Benjamin Buchanan - 9710 0451
File Ref: PAD21/0043

Pre-Application Discussion No. PAD21/0043

Proposal: Upgrade of on site parking facilities to a basement car park and increasing student capacity

Property: 16 Allies Road, Barden Ridge

Figure 56: Driveway location discussion

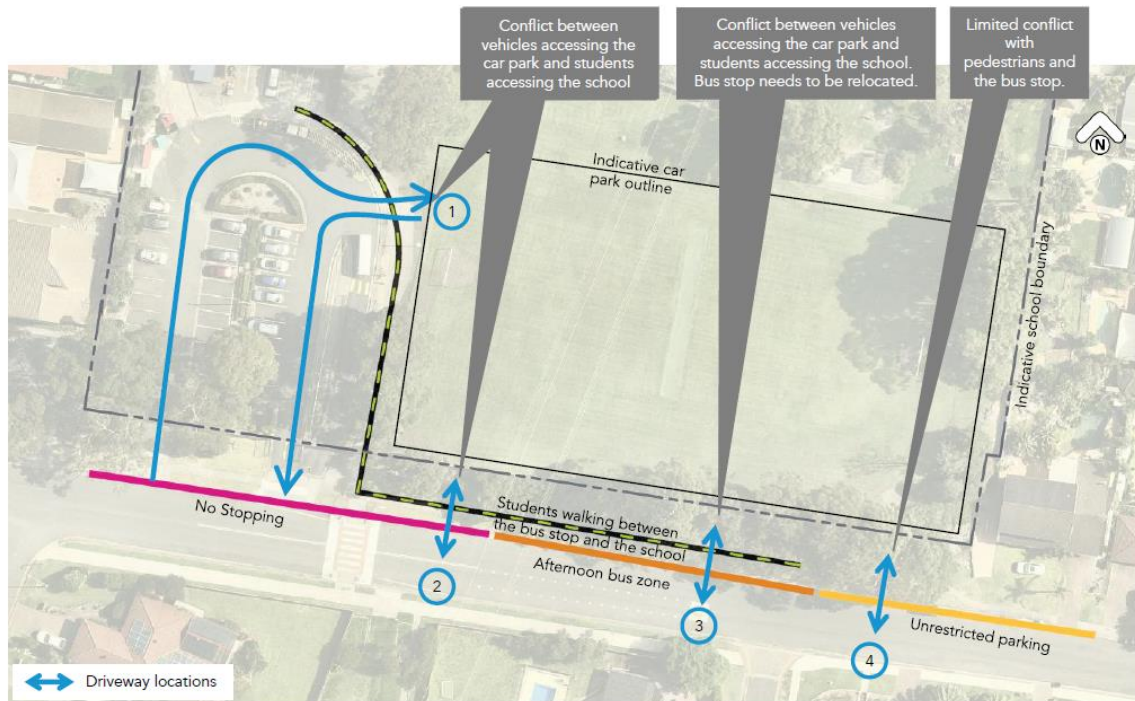
The traffic study includes a review of the existing and 3 alternative locations for an entry/exit to the car park and recommends location 4 (current proposal)

Based on the assessment locations 2 and 3 are not supported.

However, whilst location 4 remains supportable from a traffic perspective, location 1 is the preferred location for the following reasons:

- The car park is for the use of staff only on school days
- The traffic study notes that the school already manages the staff and student arrival time such that staff arrive prior to student arrival and depart after students' departure, meaning that the conflict between students and staff vehicles is minimal. An additional supervisor can be located at the driveway to manage any conflicts, should they arise.
- It internalises entry/exit to the car park thereby minimising the number of conflict points in Allies Road and maintaining greater flexibility for use of the existing kerb space in Allies Road
- It removes any potential safety impact on sight distances for vehicles exiting the car parks caused by buses waiting in the bus zone in Allies Road.

Whilst not discussed in the traffic report, location 1 does have the disadvantage of being located at the high point of the car park which may present some architectural/engineering challenges for ramping to the car park floor level.

- Location 1 be further pursued.
- A future condition of consent require the school to produce a green travel plan aimed at reducing the number of vehicle trips by encouraging car pooling and other
